VARIANCE / FIELD CHANGE NOTICE

V/F: 20600-PSP-0005-1

WBS NO.: PROJECT/DOCUMENT/ECDC # 20600-PSP-0005 Rev. 1

PROJECT TITLE: Project Specific Plan for Area 6 Solid Waste Landfill Excavation
Characterization

FIGURE 1

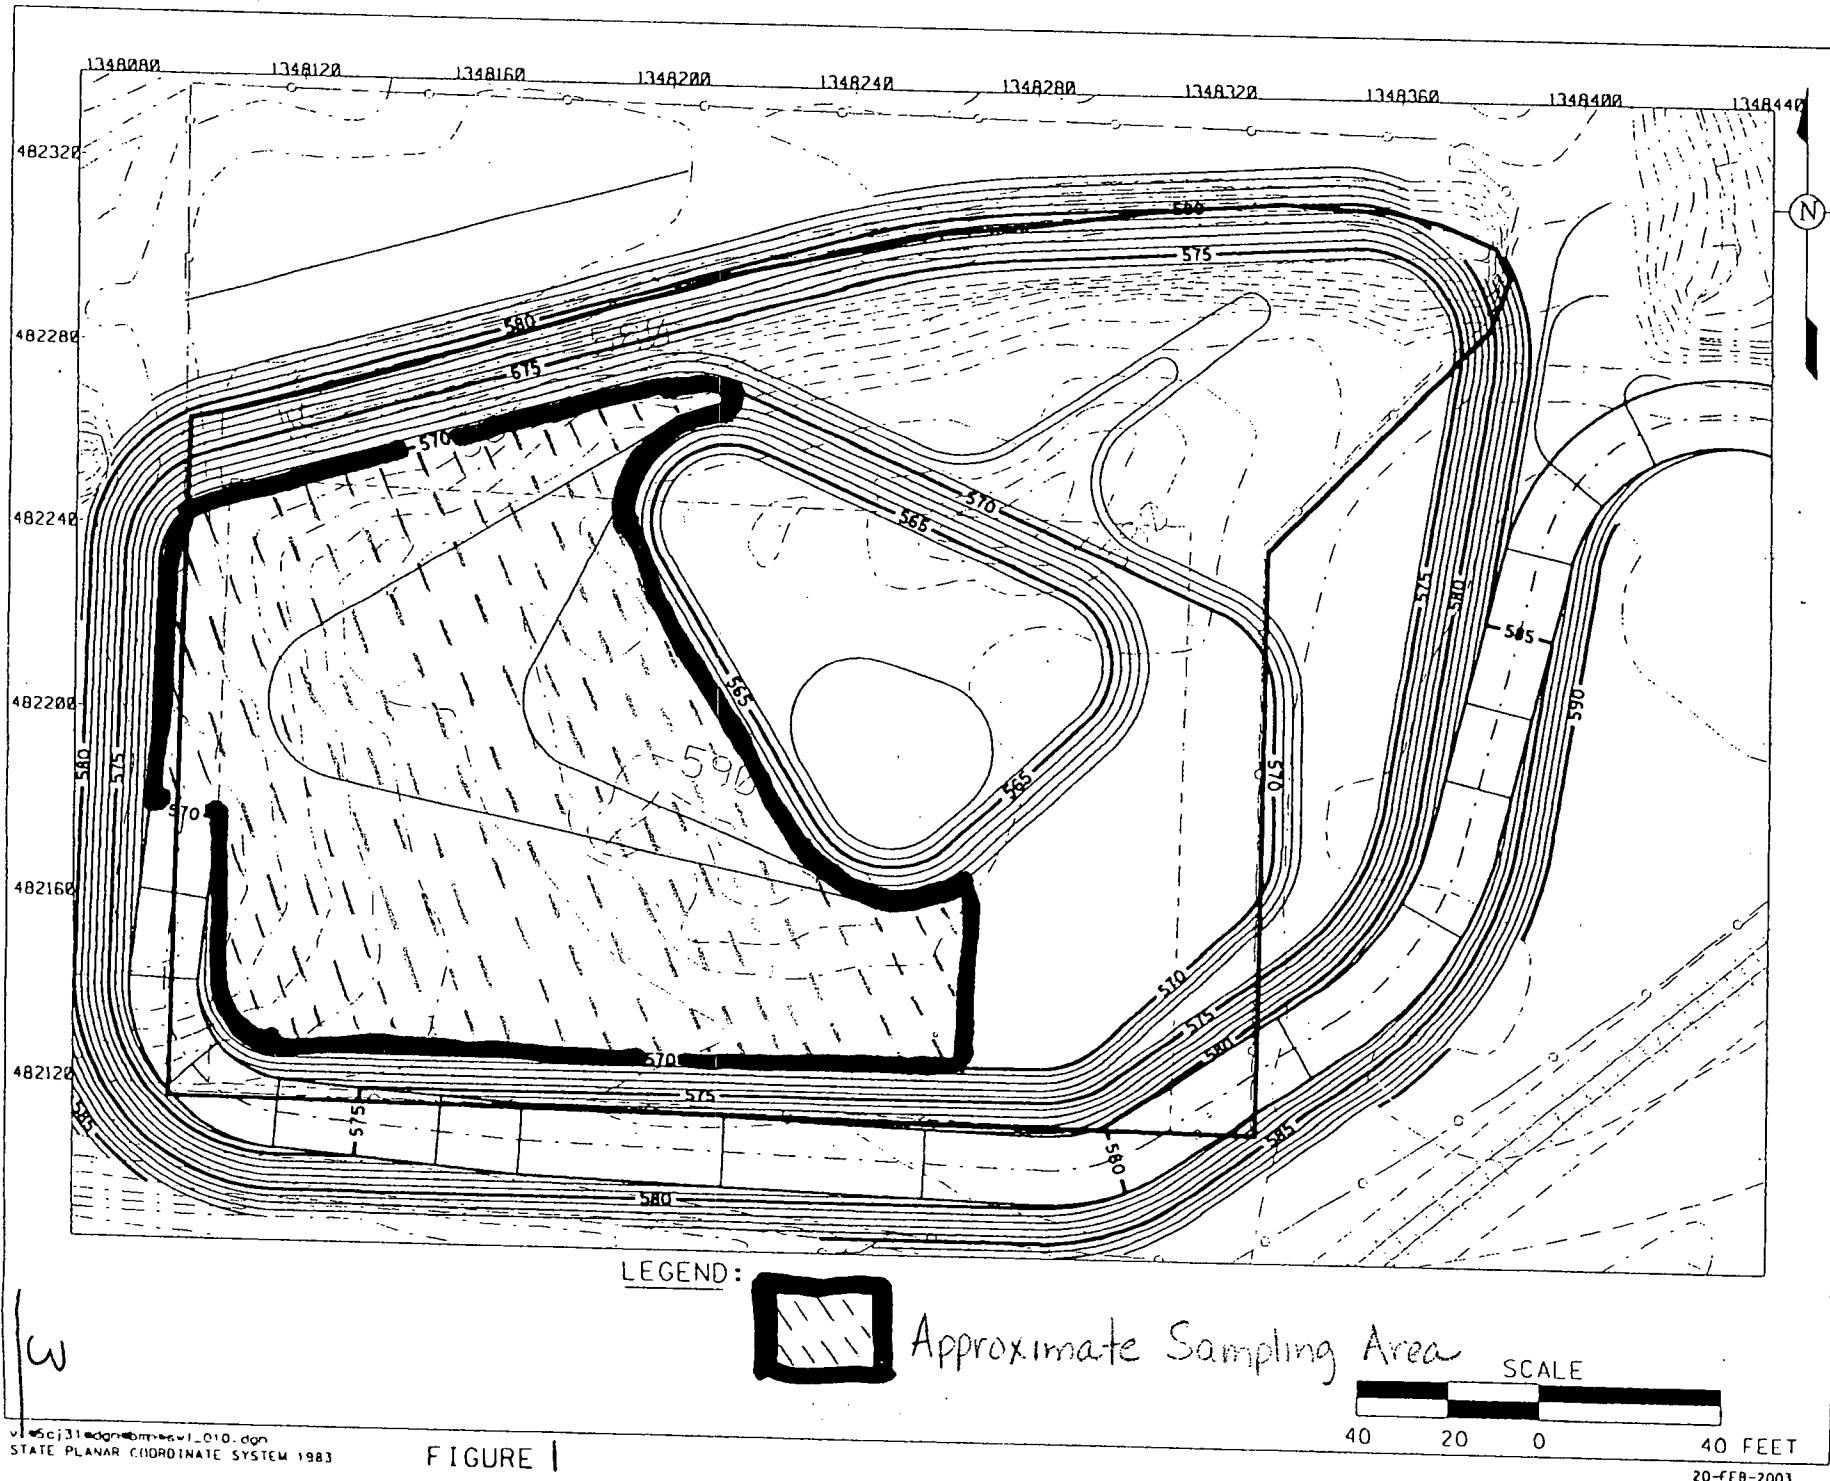
This Variance/Field Change Notice (V/FCN) documents the collection of surface grab samples for benzo(a)pyrene analysis in the Solid Waste Landfill (SWL) at the design grade at mean sea level (MSL) 570. The samples will be collected on the western half of the excavation floor and sidewalls MSL 570. See Figure 1 for the approximate area to be sampled. Coordinate with the Construction Lead for the exact location of the area.

The excavation floor will be divided into a 20' X 20' grid and a location will be marked at the center of each block. A minimum of 2 locations at representative spacing will be marked on the floor. All of the sidewalls surrounding the sample locations on the floor will be sampled. Sample locations will be marked every 20' on each sidewall within 0-4' of the floor. A minimum of 1 location per sidewall is required. At each location 1 sample will be collected for total ^{see 12/22/03}uranium (TAL B), which will be analyzed at an offsite laboratory. These samples will be taken in accordance with the PSP. See Attachment 1 for the Sampling and Analytical Requirements.
